Upgraded Squeegee Hose Assembly
Stealth AS20B, Stealth AS20BT & Stealth AS26BT
Beginning Serial Number: 209007401

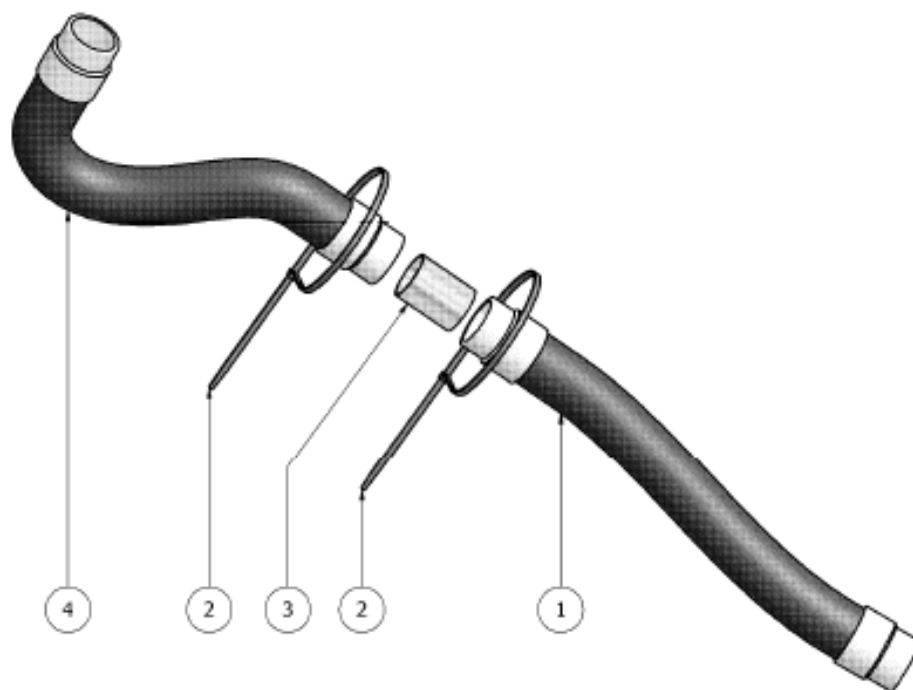
To allow easier cleaning and replacement of the Squeegee Hose Assembly, a new design using two hoses and a plastic fitting are now replacing the single hose design. The part numbers listed above are required to produce the complete assembly.

Position	Quantity	Part Number	Description
1	1	E88499	Hose, Vacuum
2	2	E83920	Clamp 9x300 4,8x360 Black
3	1	E88500	Fitting, Hose D38, W1.5, L50
4	1	E88499	Hose, Vacuum
